RE: Application MP 10_0006. Pindimar Abalone Project.

As a permanent resident I object to the Pindimar Abalone Project for the following reasons:-

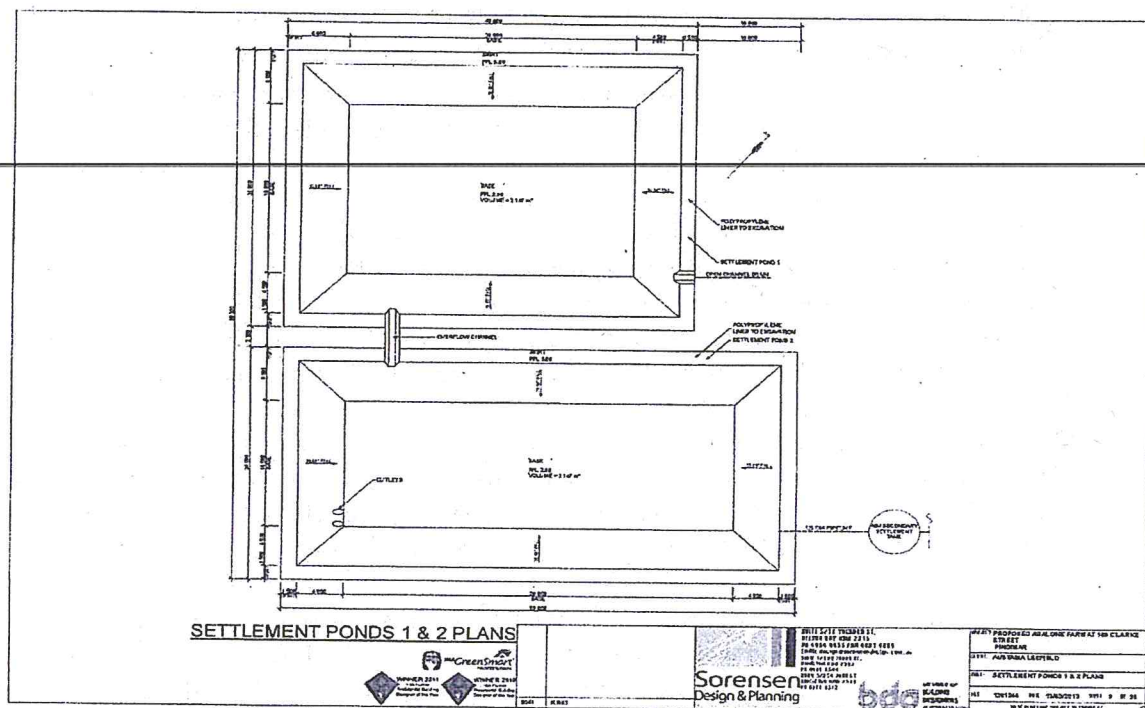
3. Settlement Pond #2. The design for Settlement Pond #2 is not conducive to settlement and detracts from the purpose of the Marine Water Quality Management System.

- Refer to attached Settlement Ponds 1 & 2 Plan from Appendix 2 of the EAR.
- Pond 1 is a relatively standard design with solids settling out in the pond as the velocity slows, this pond then overflows to Pond #2 via a high level overflow channel.
- Pond 2 has inlets from Pond #1 and Settlement Tank #2. Dual outlets with a capacity of around 580l/s at the bottom or invert of the pond mean it's unlikely to operate as a standard settlement pond as what comes in will go straight out with no detention.
- There is no clear explanation or methodology shown as to how Settlement Pond #1 will be by-passed for periodic cleaning or how flow will be diverted to Pond #2.

- Figure 17 Marine water Quality Management System –Conceptual View attached

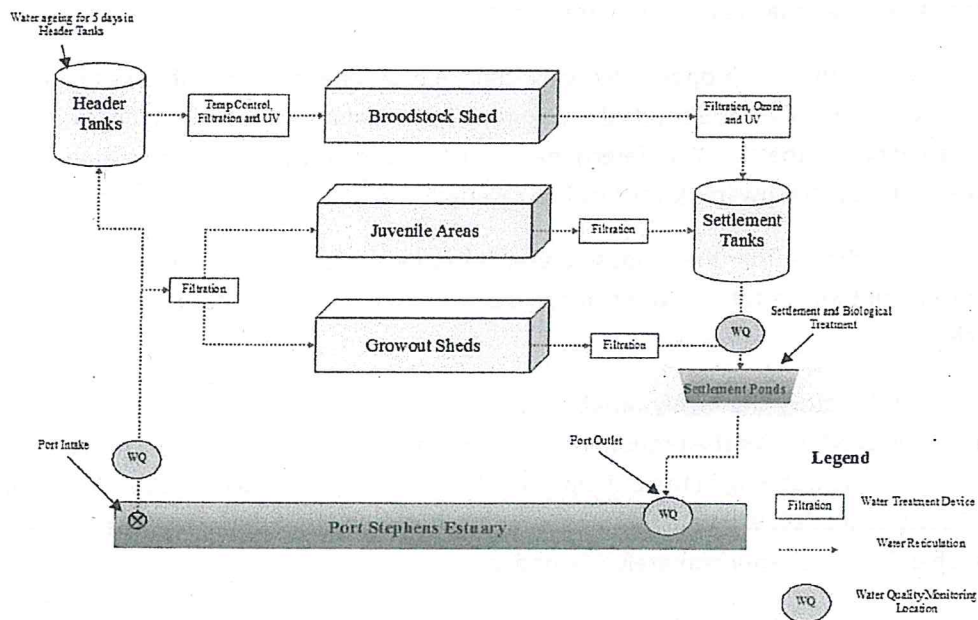
- The configuration of Settlement Pond #2 as currently shown indicates that discharge water from the Broodstock and Juvenile Areas via the Settlement Tanks will not undergo Settlement Pond residence time.
